PROPOSED RESIDENTIAL APARTMENT COMPLEX 3-STORY

FREEDOM SPRINGS
734 WESTERN DRIVE
COLORADO SPRINGS, EL PASO COUNTY,
COLORADO 80915

SITE DEVELOPMENT PLAN
SDP

ADA ROUTE DETAIL
SCALE: 1" = 20"

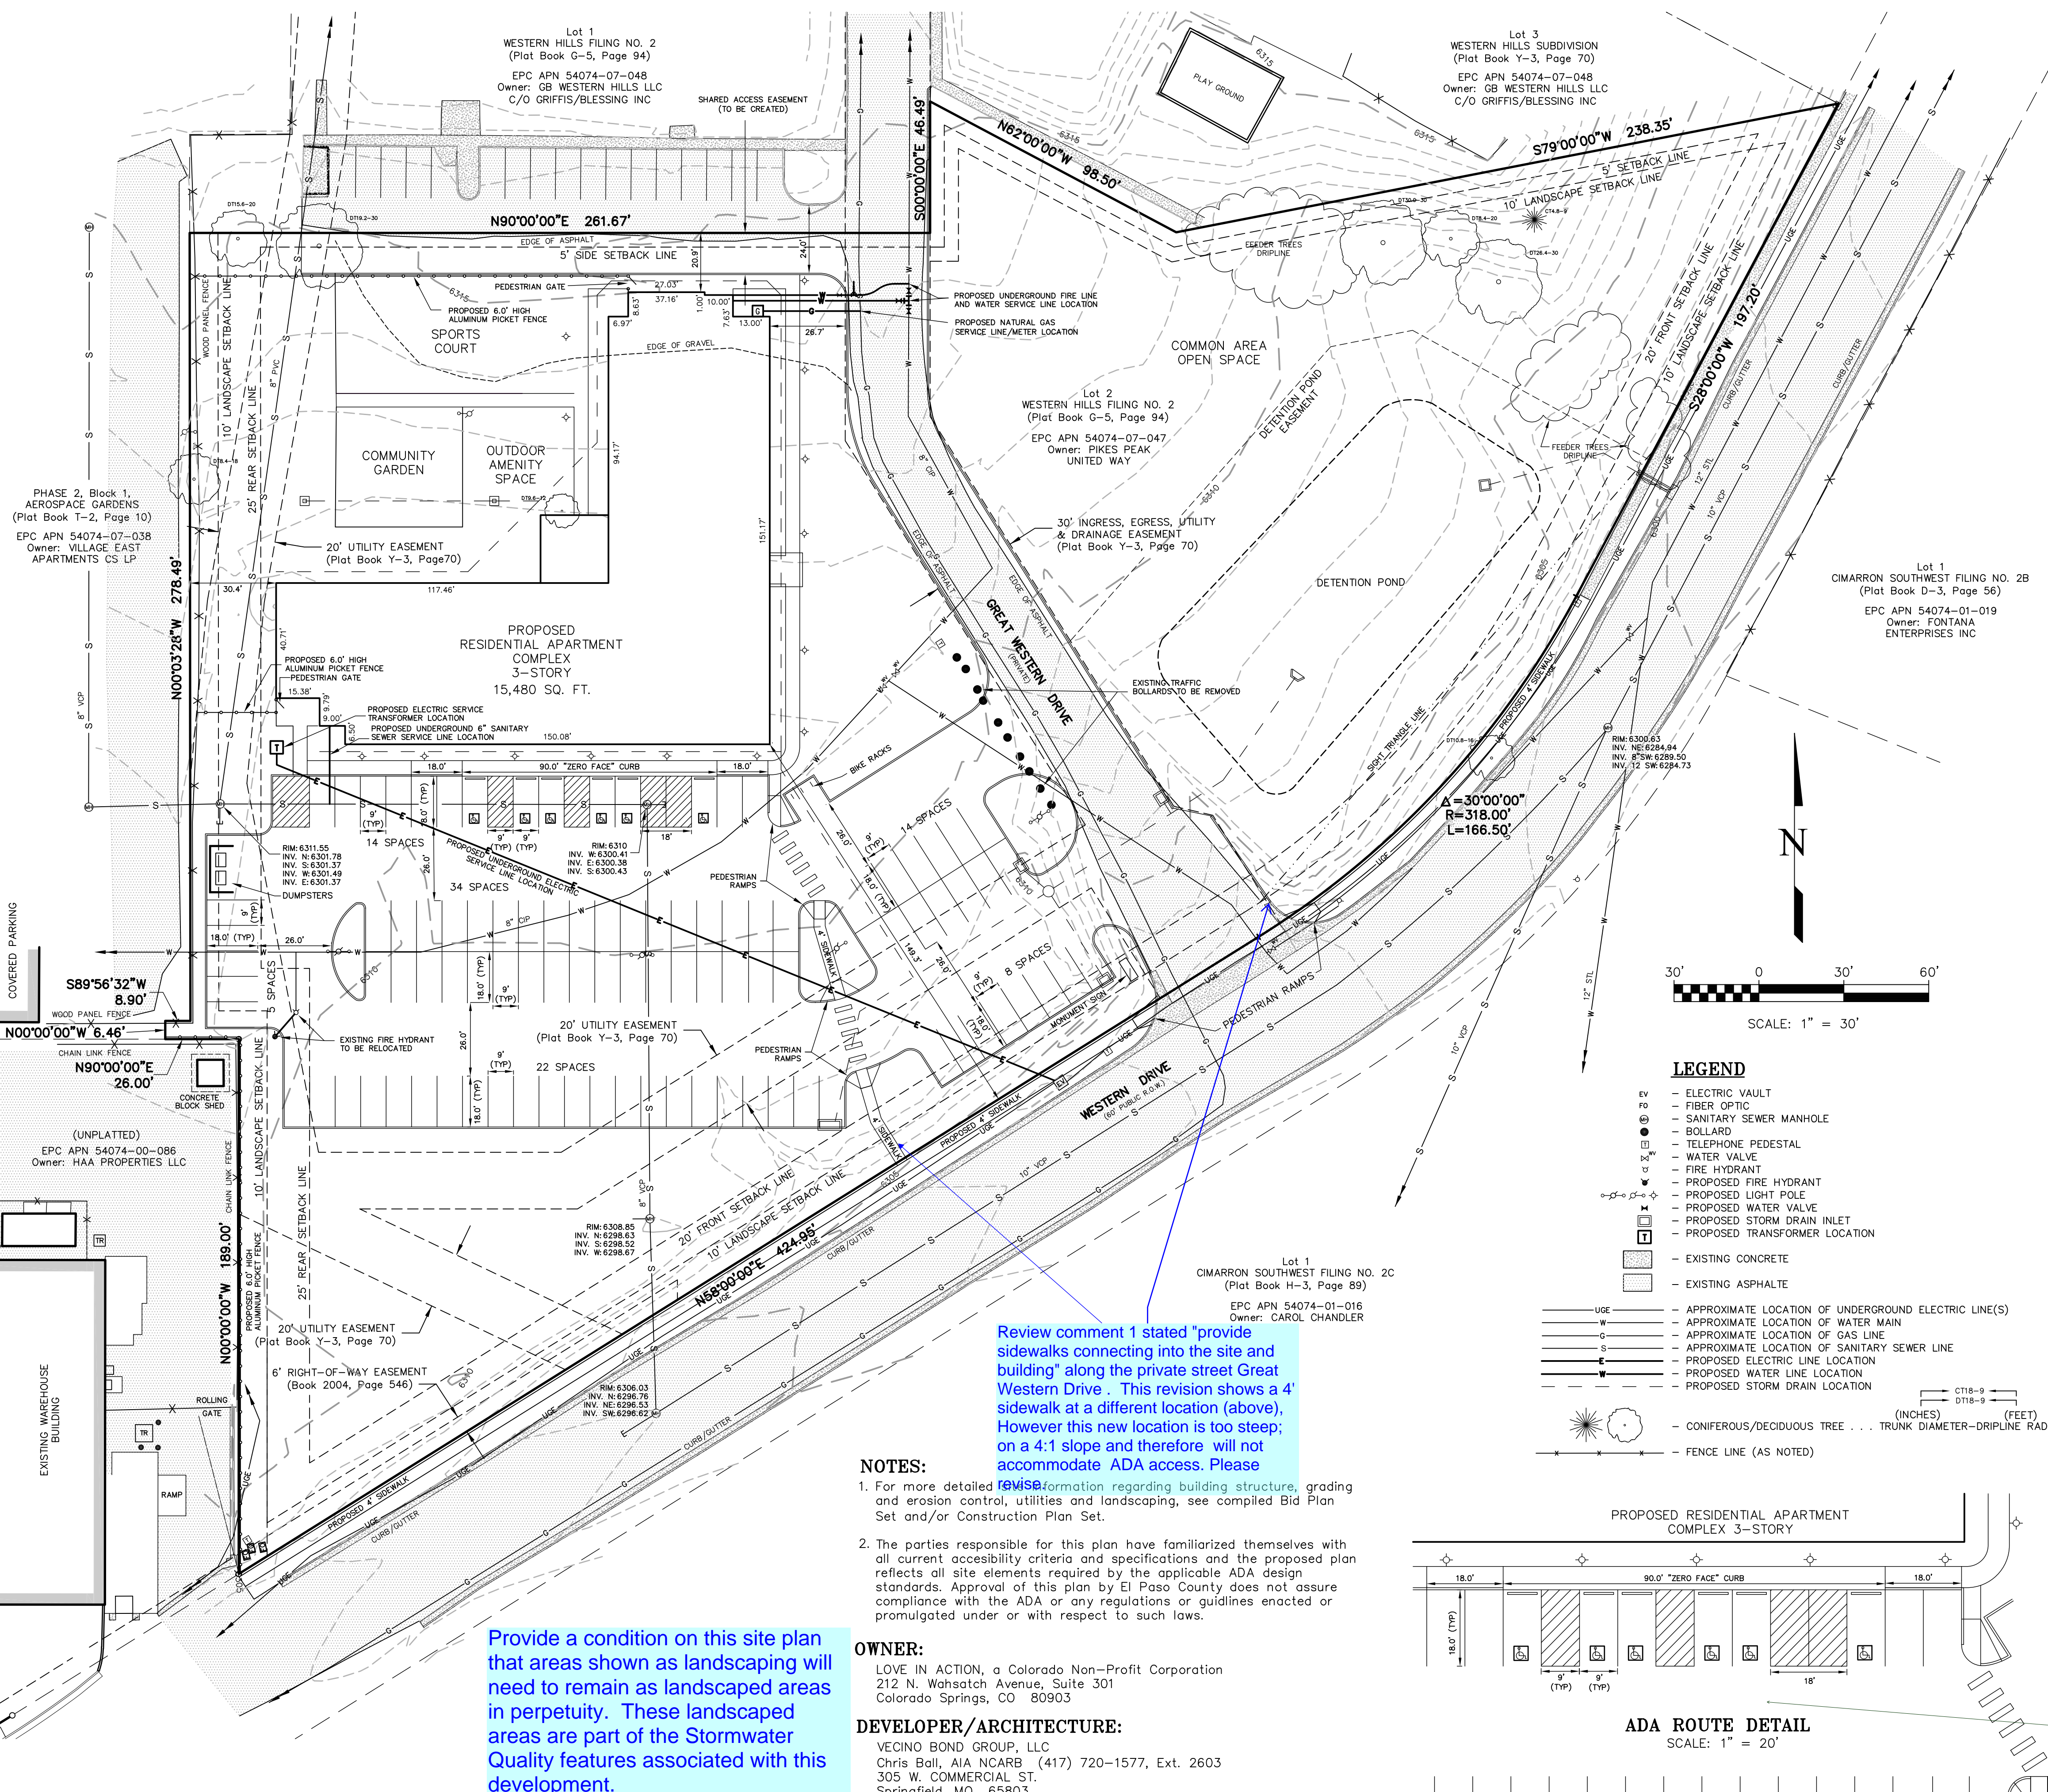
This is not an ADA route, this is showing the parking, per original comment, an separate sheet indicating the ADA route for the site is required.

Review comment 1 stated "provide sidewalks connecting into the site and building" along the private street Great Western Drive. This revision shows a 4' sidewalk at a different location (above). However this new location is too steep; on a 4:1 slope and therefore will not accommodate ADA access. Please

Provide a condition on this site plan that areas shown as landscaping will need to remain as landscaped areas in perpetuity. These landscaped areas are part of the Stormwater Quality features associated with this development.

1 SITE PLAN
1" = 30'-0"

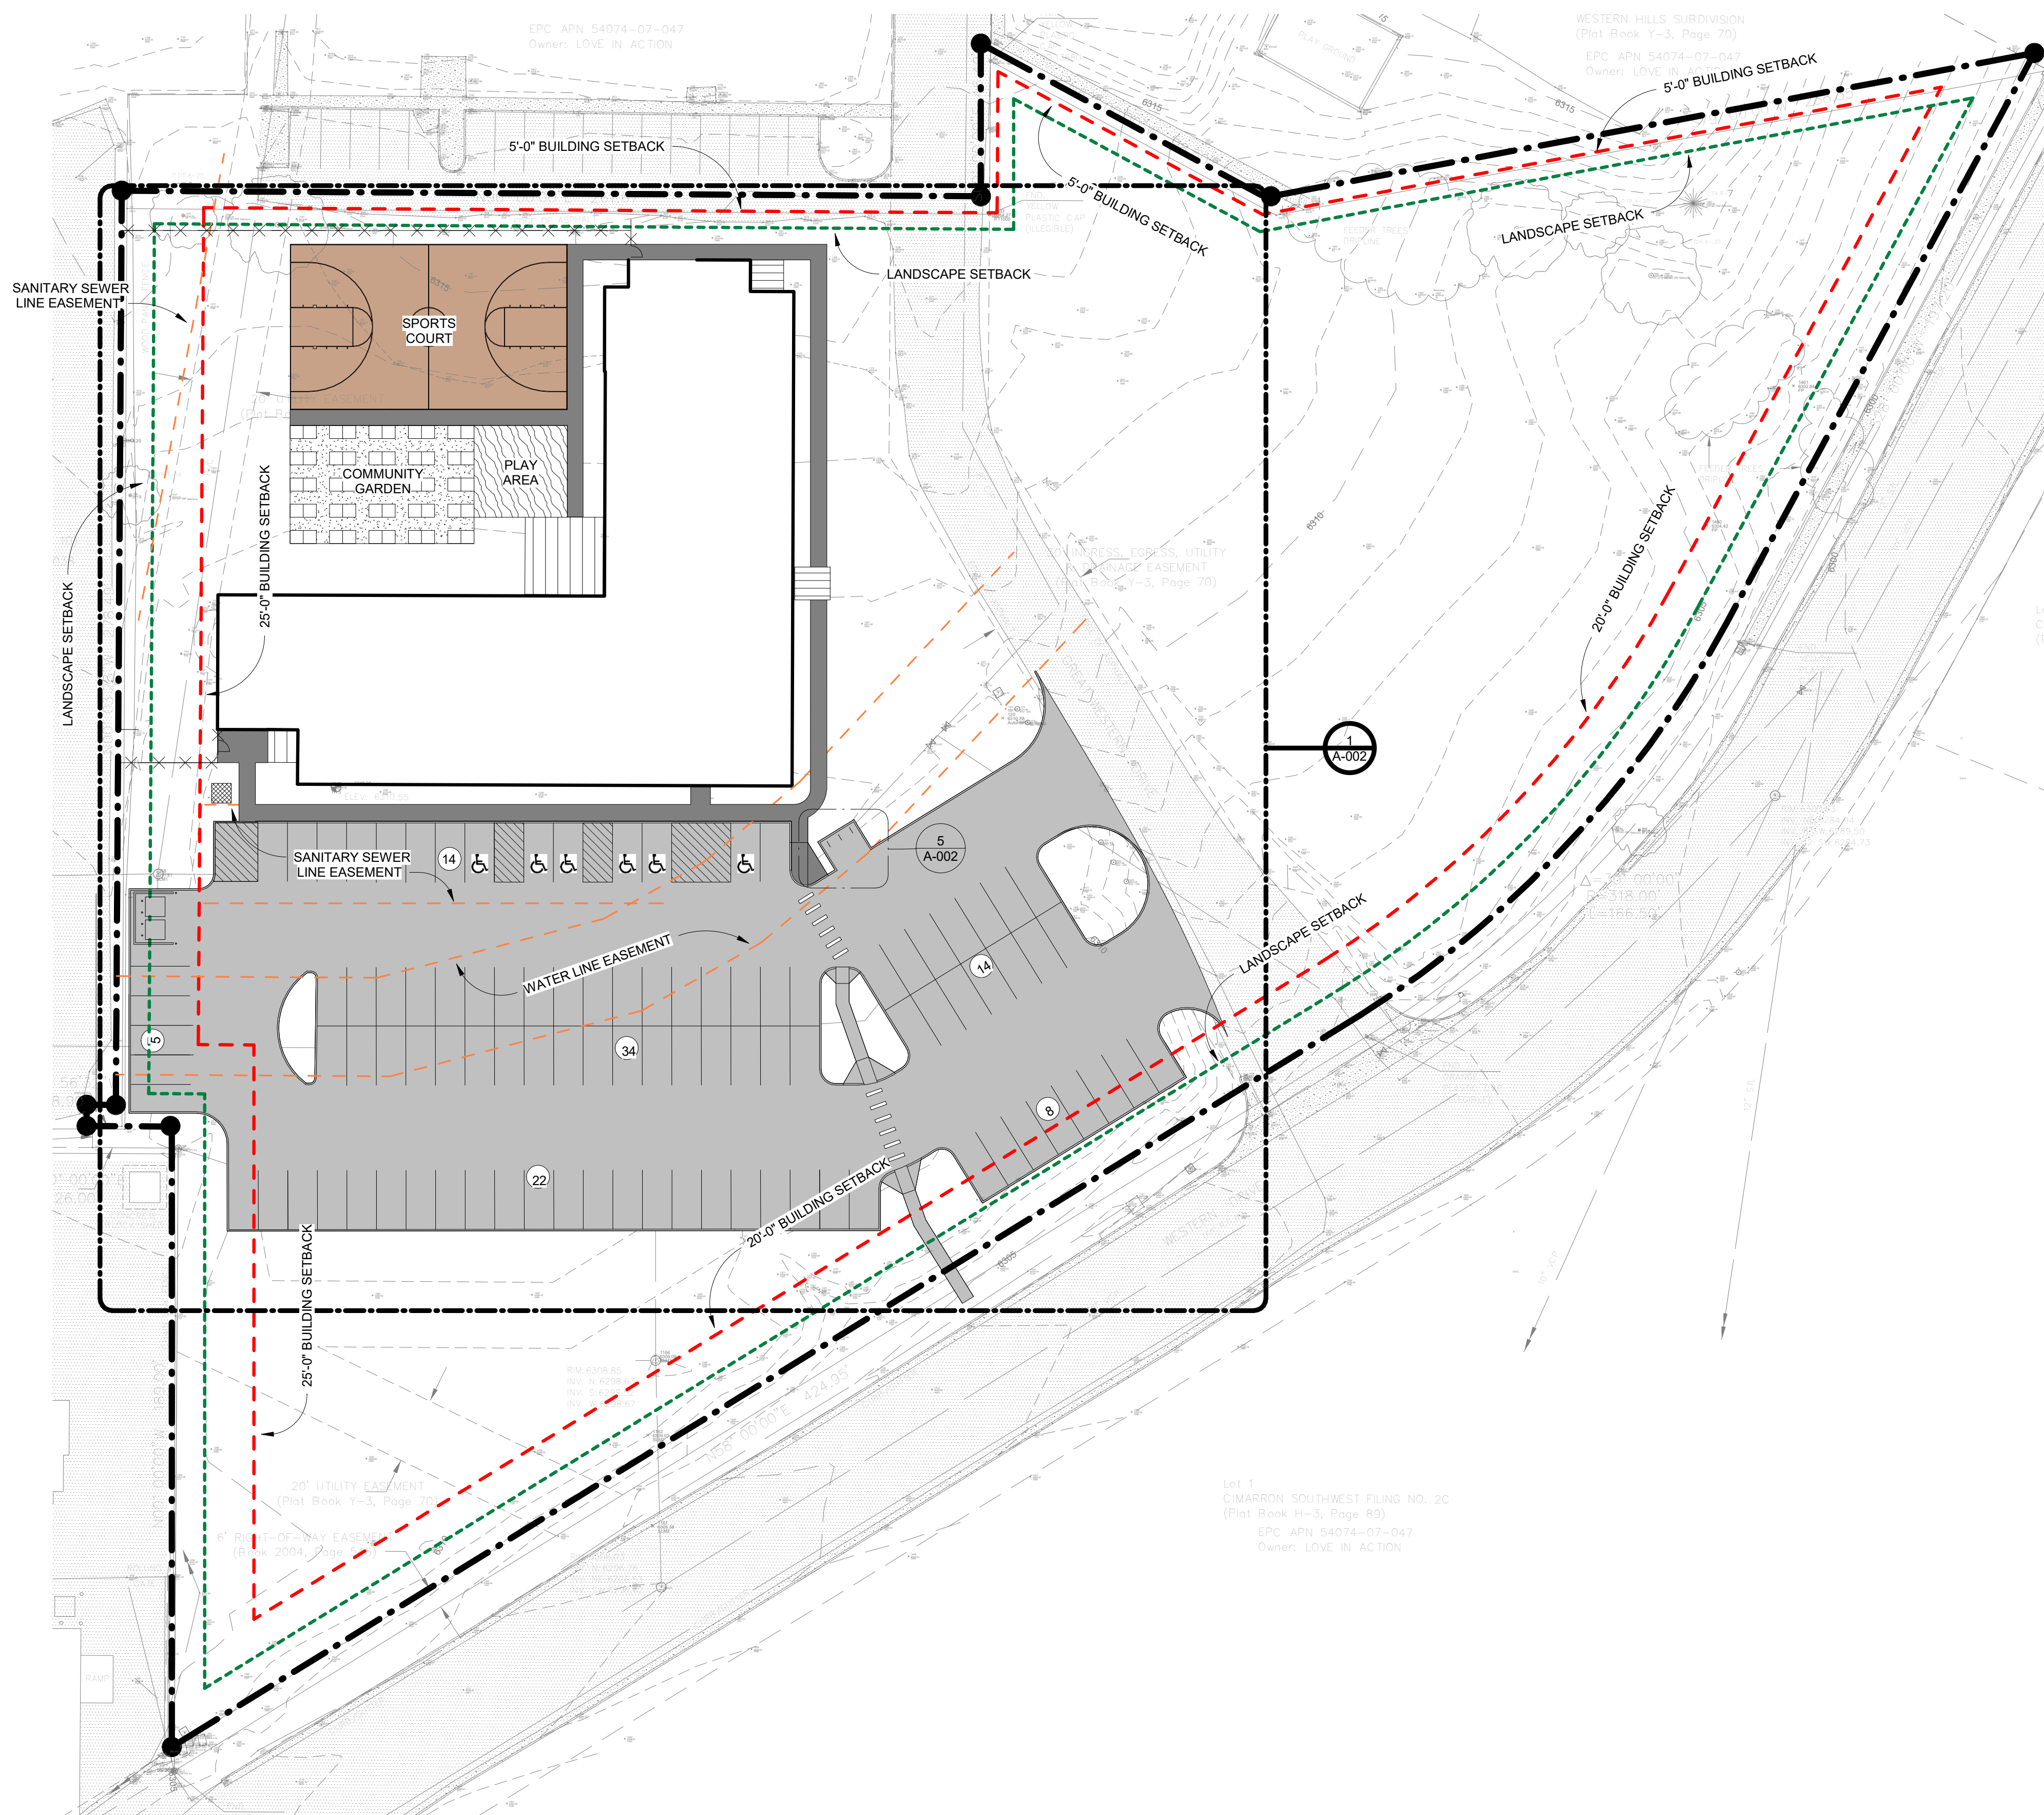
What is this page referring to? There is no legend, and at one point the red hatch line is shown to be a 20' building setback, in another a 5' building setback.

1 ENLARGED SITE PLAN
1" = 20'-0"

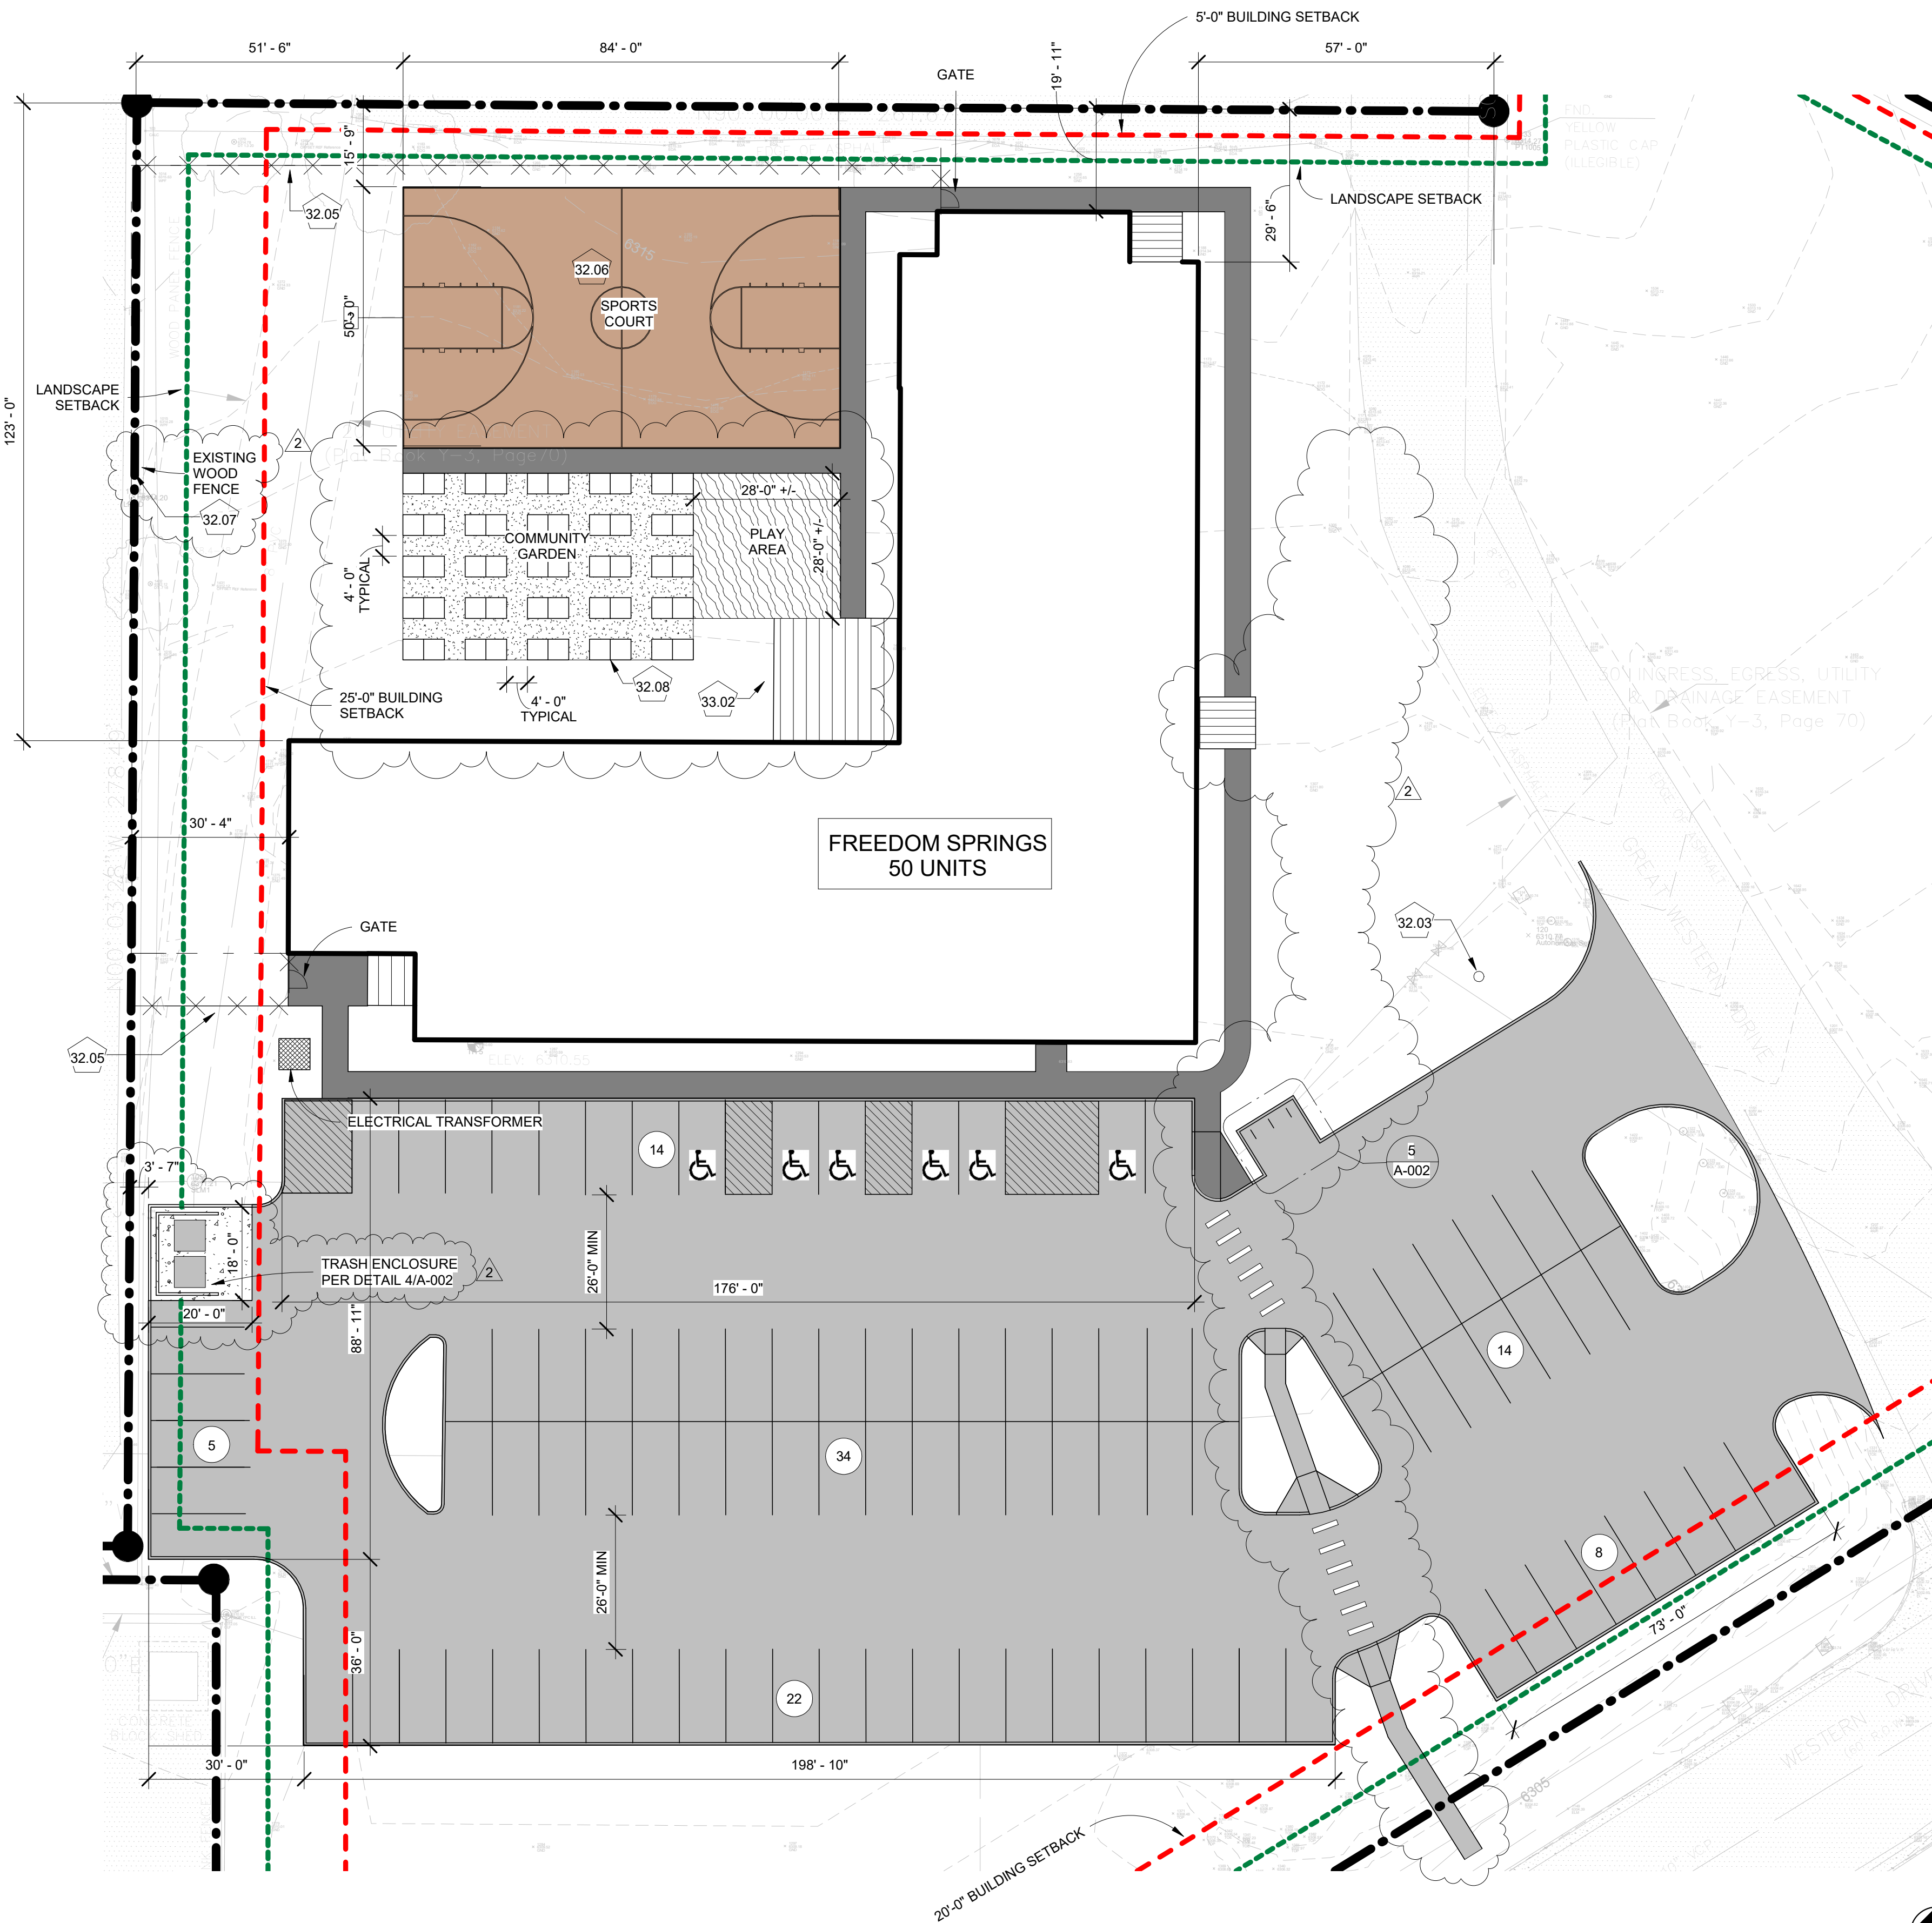
Elevations required, Approval from utility company granted
